MM Docket No. 92-59

Amendment of Section 73.202(b), Table of Allotments, FM Broadcast Stations (Bradenton, Florida)

COMMENTS OF ENTERTAINMENT COMMUNICATIONS, INC.

ENGINEERING STATEMENT IN SUPPORT OF COMMENTS IN THE MATTER OF MM DOCKET NO. 92-59 AMENDMENT OF SECTION 73.202(b) TABLE OF ALLOTMENTS, FM BROADCAST STATIONS BRADENTON, FLORIDA

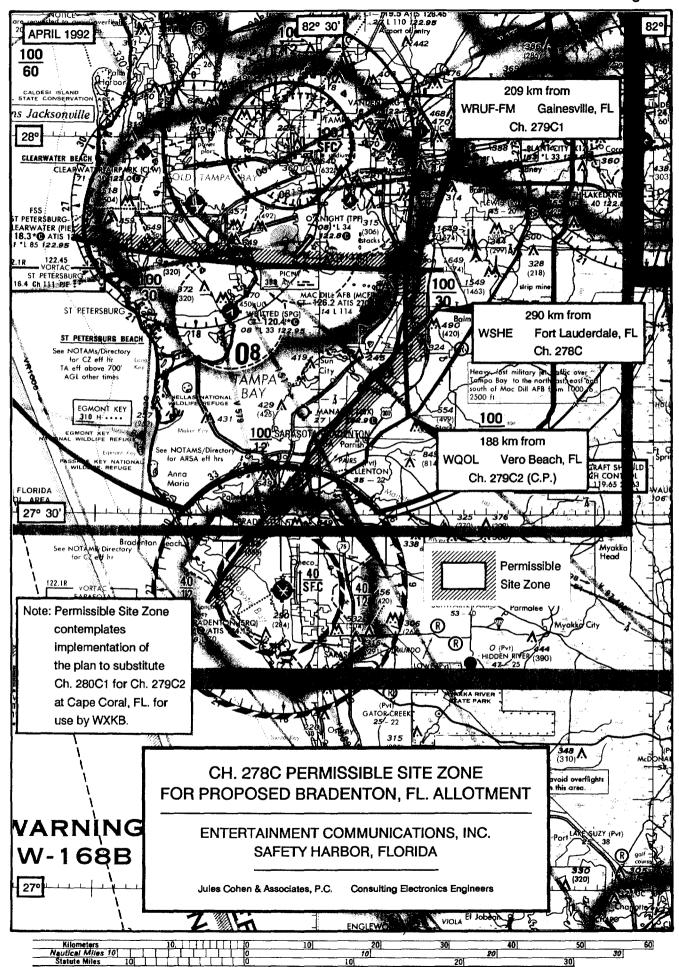
Attached herewith as Figure 1 is a portion of a Sectional Aeronautical Chart on which the permissible site zone for the channel 278C allotment to Bradenton has been plotted. While not specifically labeled, a small circle near the intersection of the 188-kilometer constraint from station WQOL, Vero Beach, Florida, and the 209-kilometer constraint from Station WRUF-FM, Gainesville, Florida, identifies the site represented by the reference coordinates specified for the allotment, i.e., 27° 49′ 20″ NL, 82° 21′ 50″ WL.

The map of Figure 1 was sent to Aviation Systems Associates, Inc. (ASA), recognized experts in obstruction evaluation studies, with a request that they evaluate if a Determination of No Hazard to Air Navigation could be obtained from the FAA for a structure having an overall elevation of 1049 feet above mean sea level at the specified reference site. If the result of that study turned out to be negative, then ASA was to evaluate if a Determination of No Hazard could be achieved for a structure having an overall height of 1049 feet above mean sea level for any location within the permissible channel 278C site zone. The ASA study is attached elsewhere as part of these Comments. The ASA study concludes that the maximum height that could be achieved at the specified site or at any site within the channel 278C permissible site zone is 649 feet AMSL. A structure having an overall height of 649 feet AMSL will not permit attainment of an antenna height above average terrain of 984 feet (300 meters) which is the minimum required for a Class C station.
